APPLICATION FOR PERMISSION UNDER SECTION 16 OF THE TOWN PLANNING ORDINANCE (CAP.131)

For Official Use Only 請勿填寫此欄	Application No. 申請編號	A/96-KN/757
	Date Received 收到日期	4 MAR 2021

Proposed Temporary Animal Boarding
Establishment
For a Period of 5 Years

Temporary Animal Boarding Establishment for a Period of 5 Years
(A/YL-KTN/757)

Appendix 4

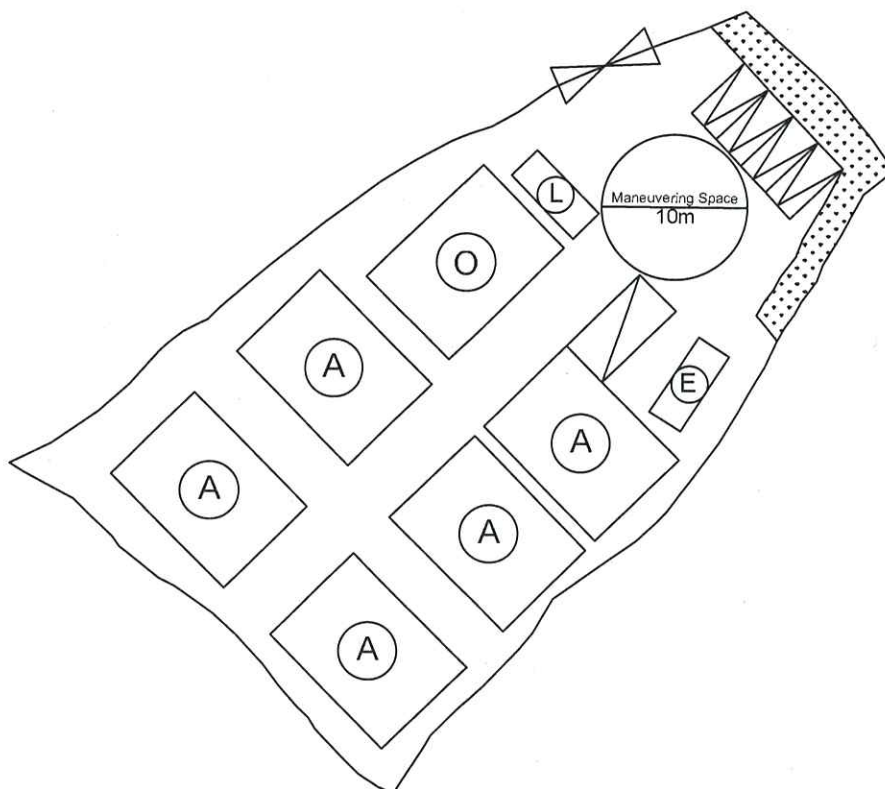
在申請地點內有一個直徑約 10 米的圓形空間，足夠讓車輛進行調遣的動作，不會在公用道路上讓車輛等候進入本申請地點，停泊在公用道路及以倒後形式進出本申請地點。參考文件末端的 Appendix 4。

道路相片：

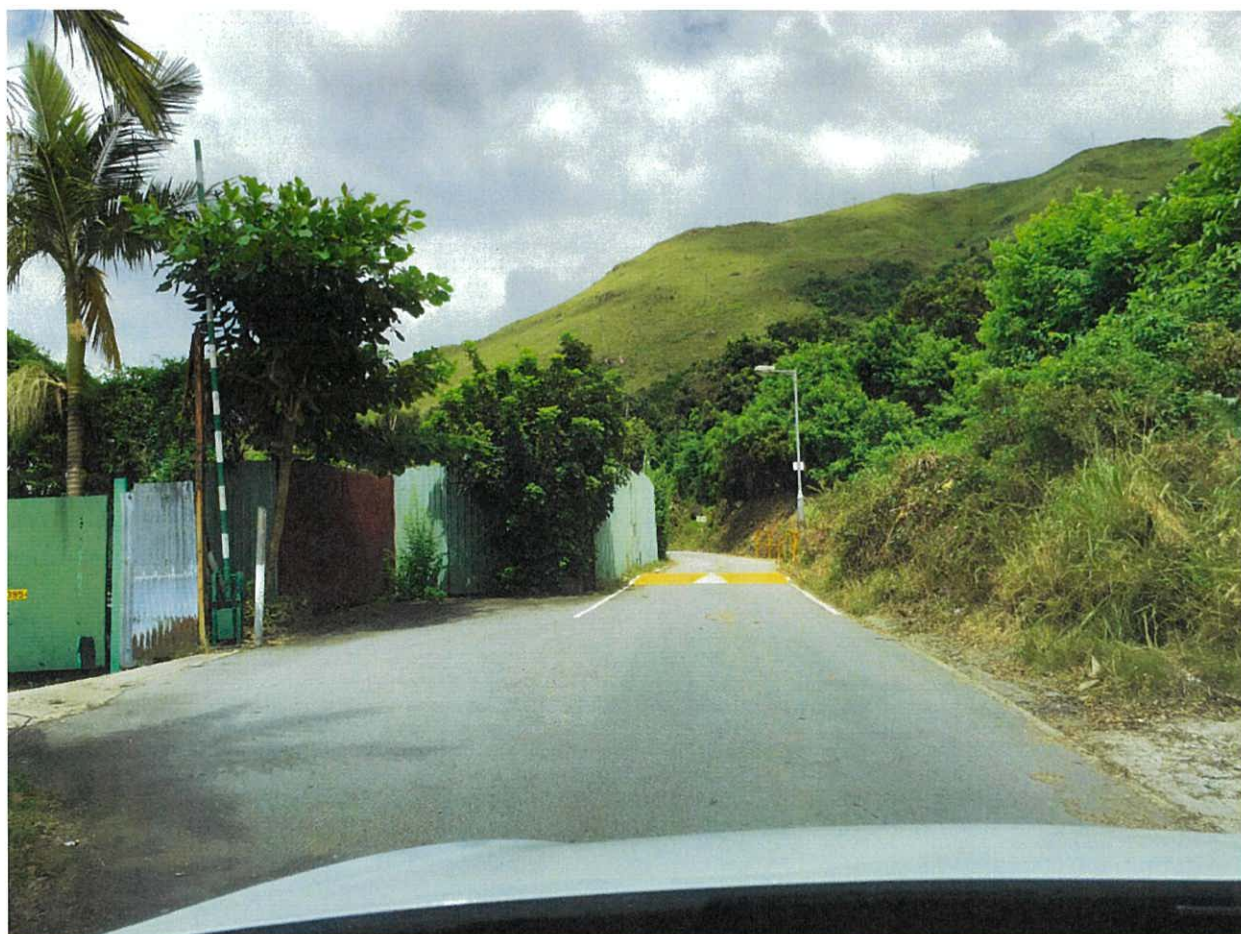
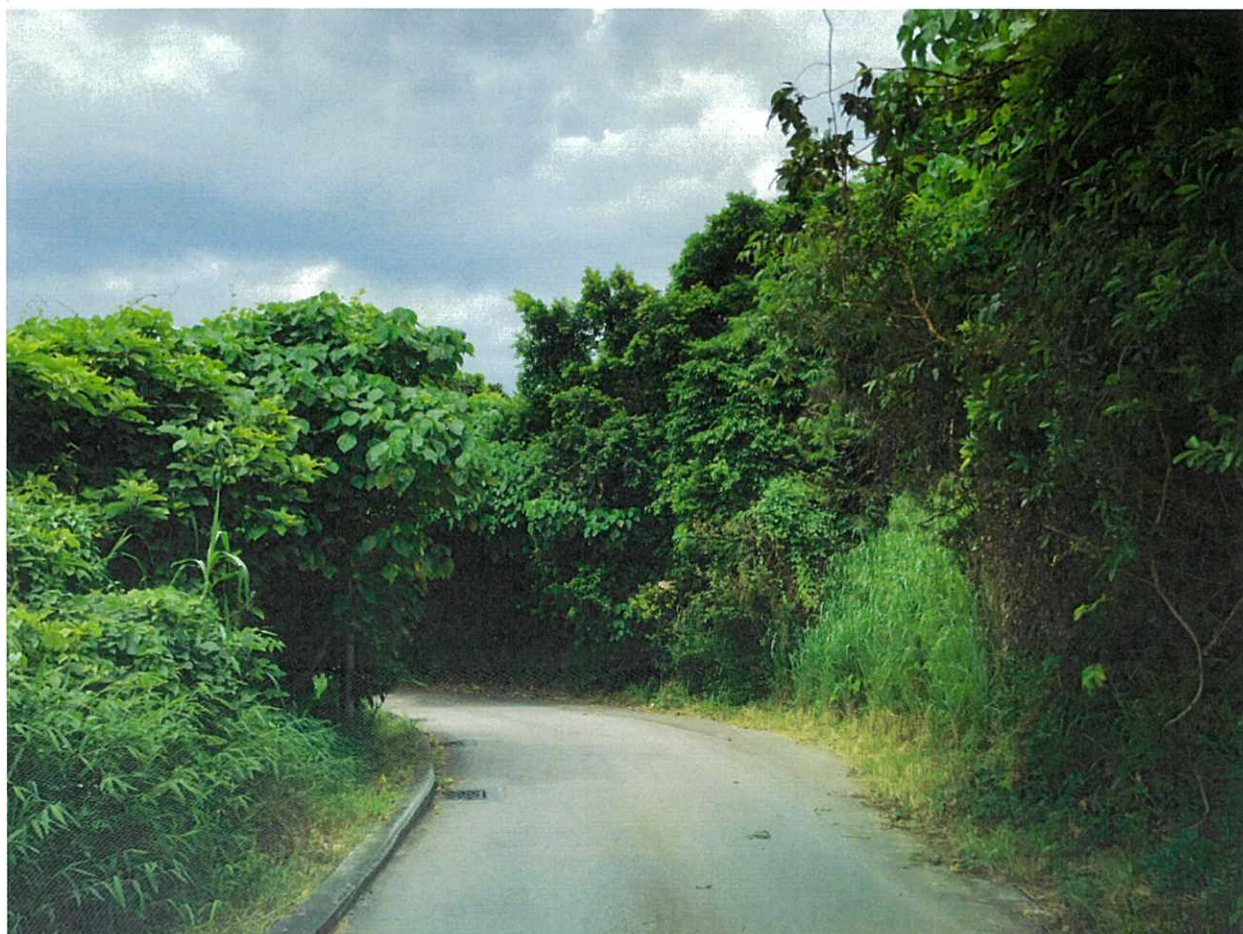
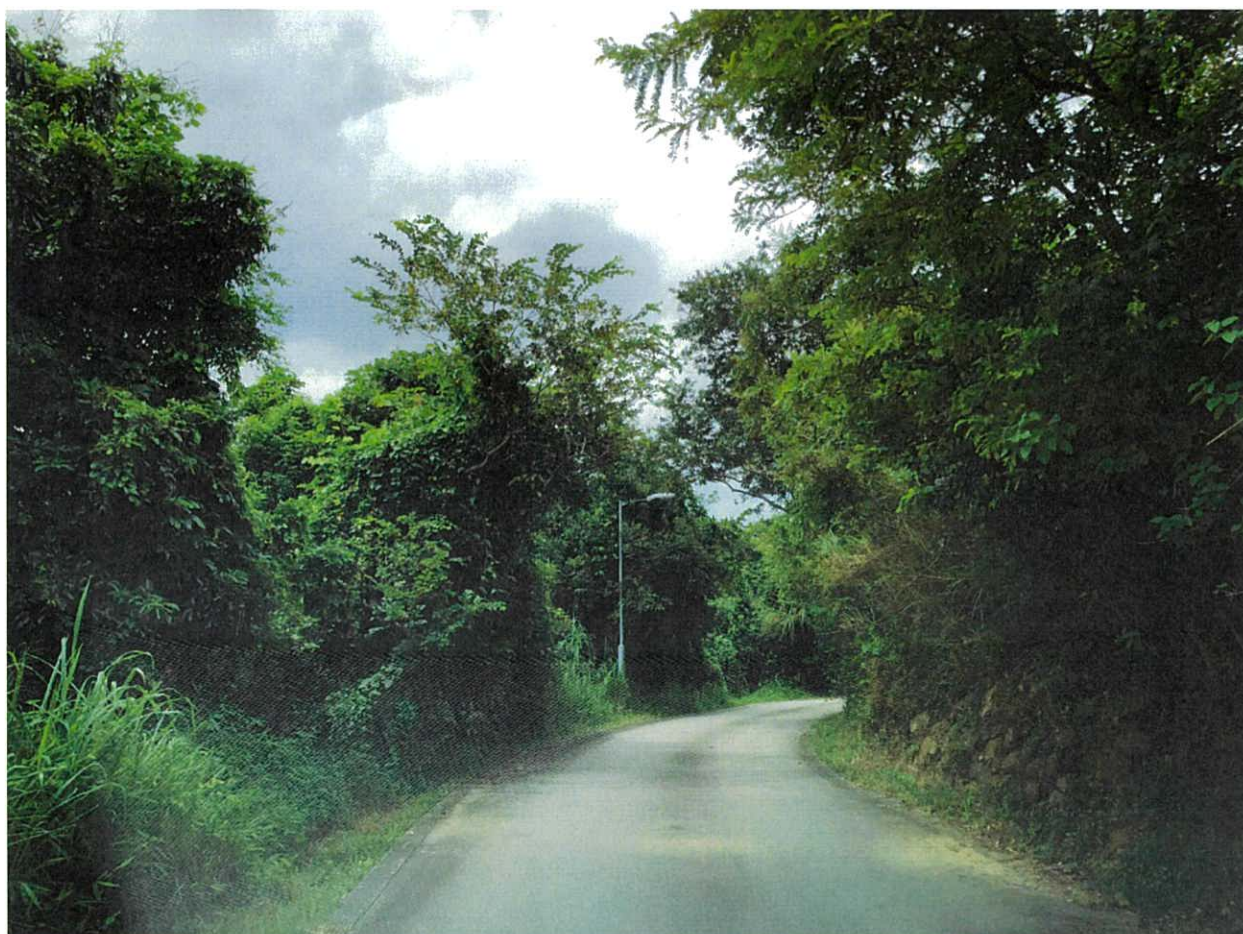
申請地點已有道路可進入，途經逢吉鄉路，最後大約 20 米進入申請地點的道路，現時已有一條約有 4 米闊以硬物鋪平的通道進入申請地點。沿途道路至少有 3 米闊，最多約有 6 米闊，直達申請地點，沿途也有避車處，客貨車有足夠的位置通過。前往申請地點及可調動位置請參考 Appendix 3，沿途道路情況請參考文件末端。
